THE PORT AUTHORITY OF NY & NJ

ADDENDUM # 1

To prospective Proposers on RFP # 59136: Request For Proposals for the Provision of a Turnkey Solution, Including Maintenance, of a Gunshot Detection System at Newark Liberty International Airport – Three (3) Year Contract:

Level 1 Plan

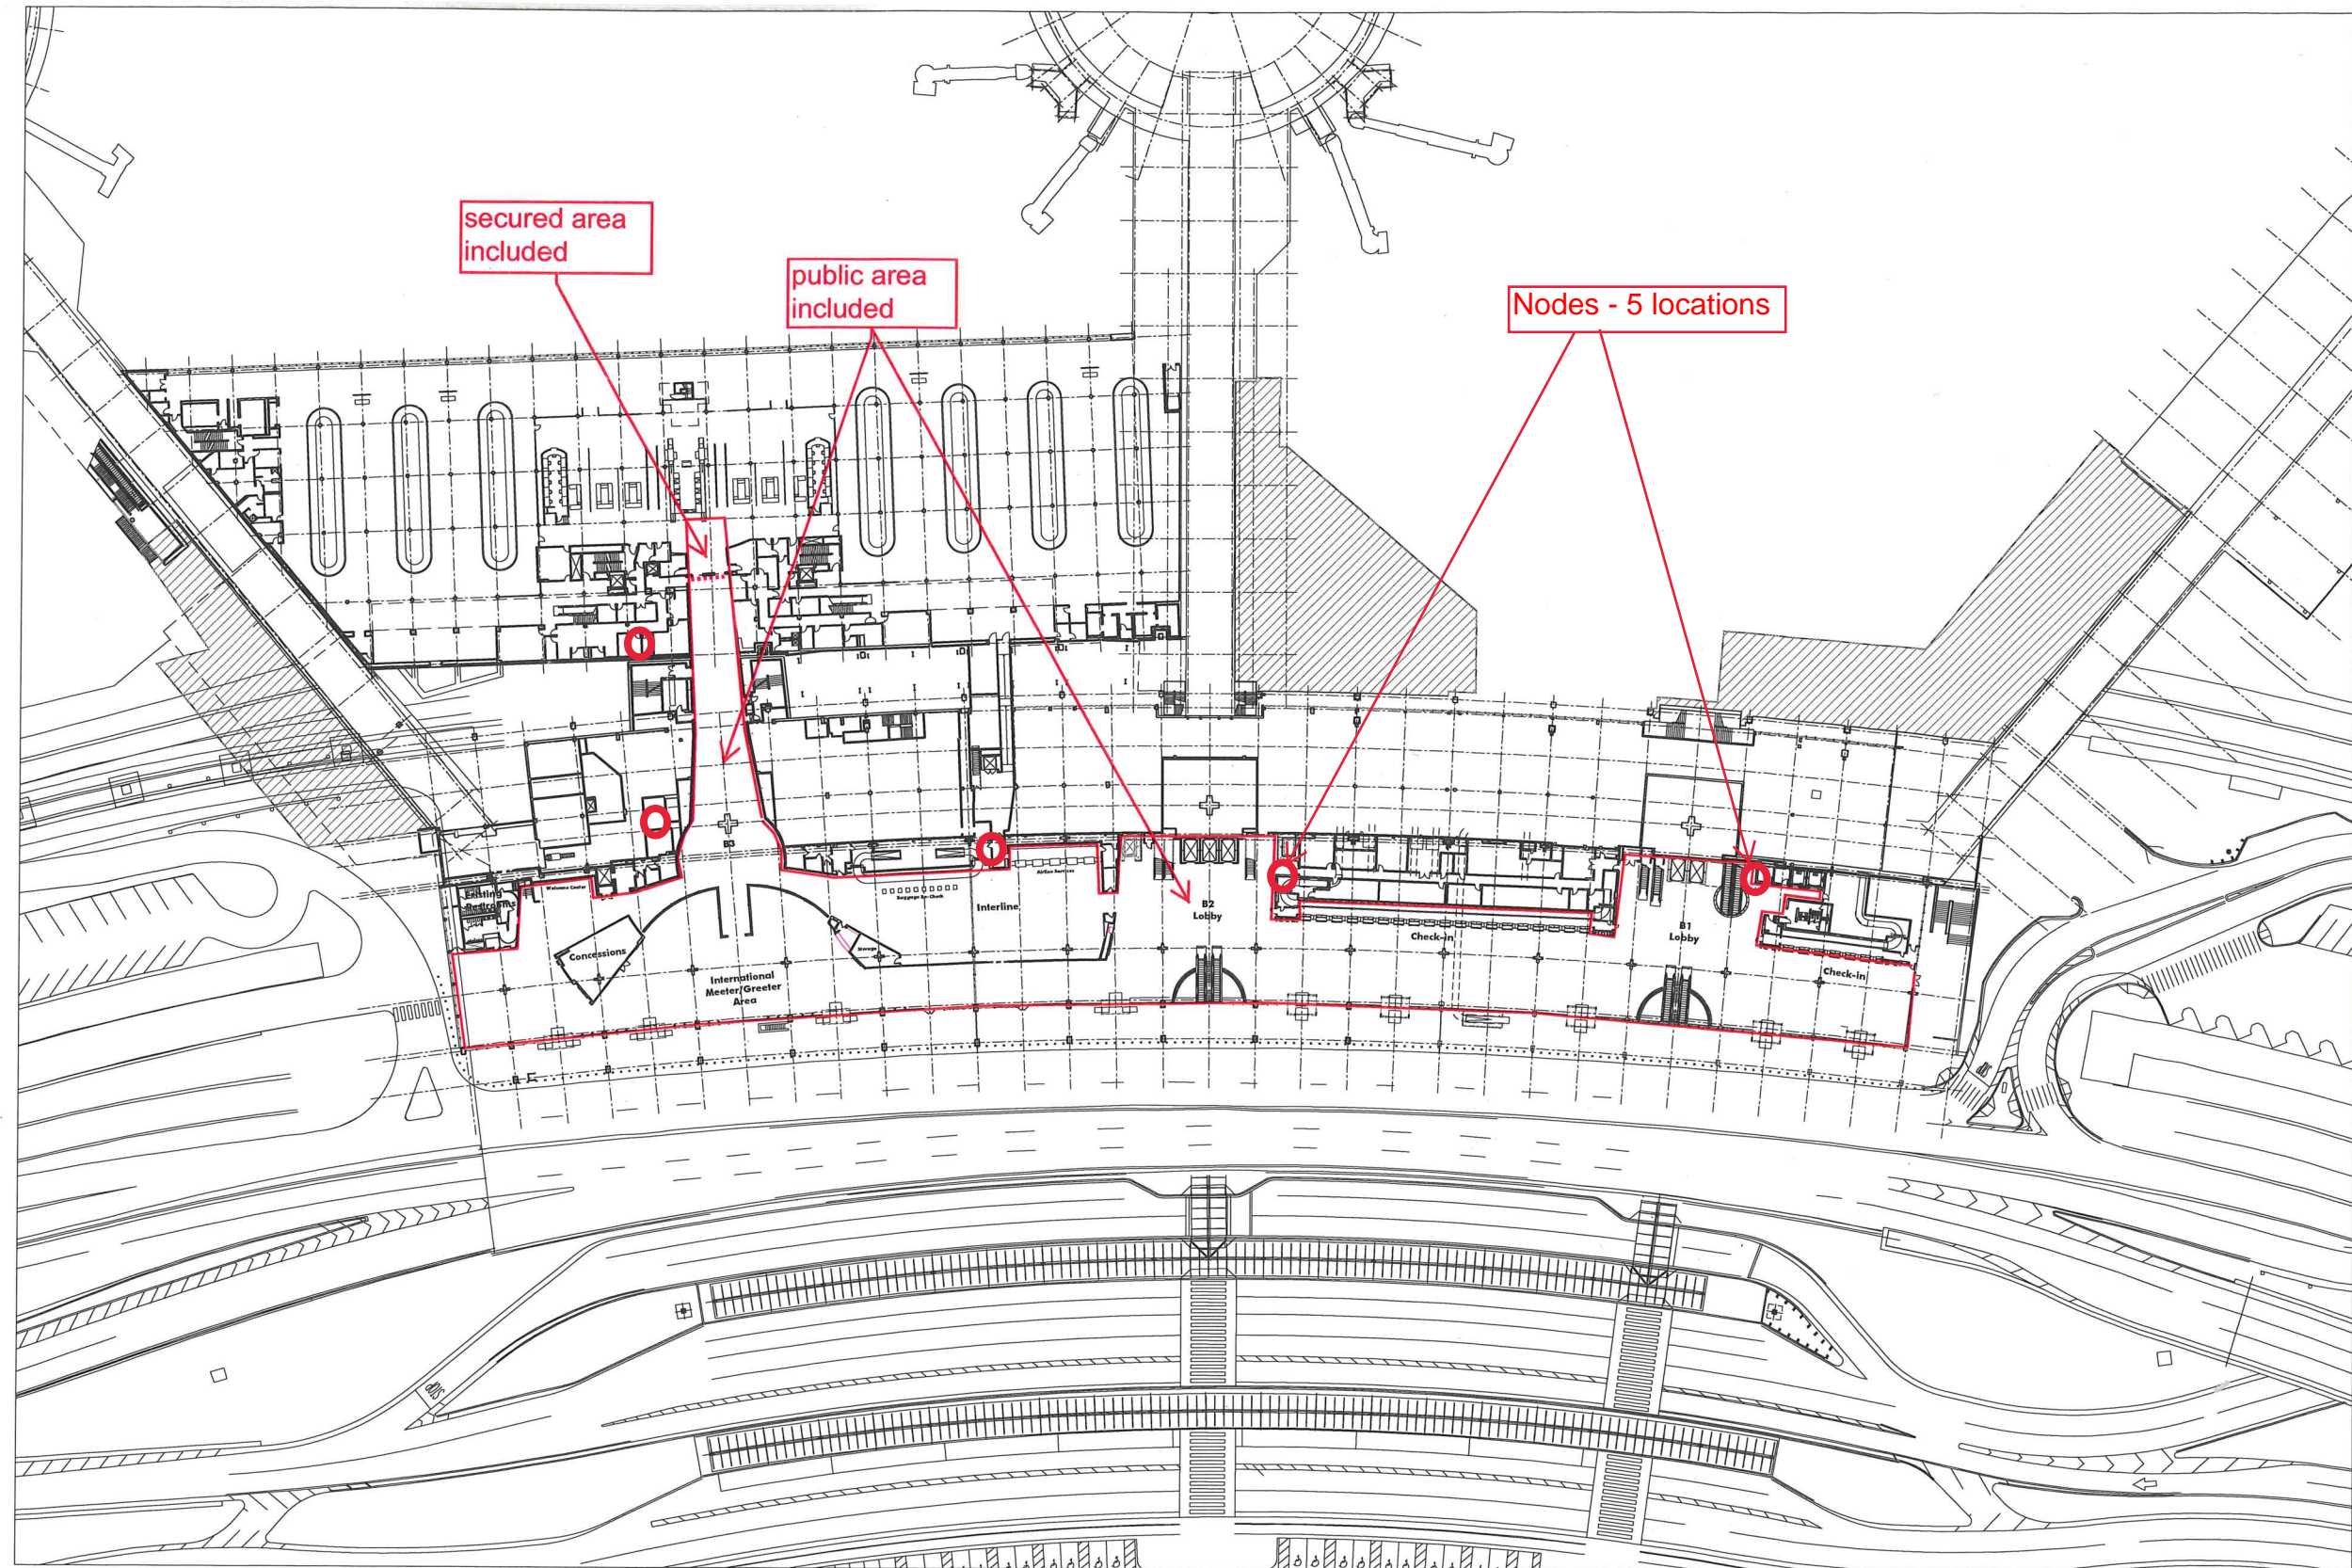
Question #1	Please provide the clearest available copies of Attachment H “Maps/Plans of the Coverage Areas at EWR”.
Answer #1	See attached.
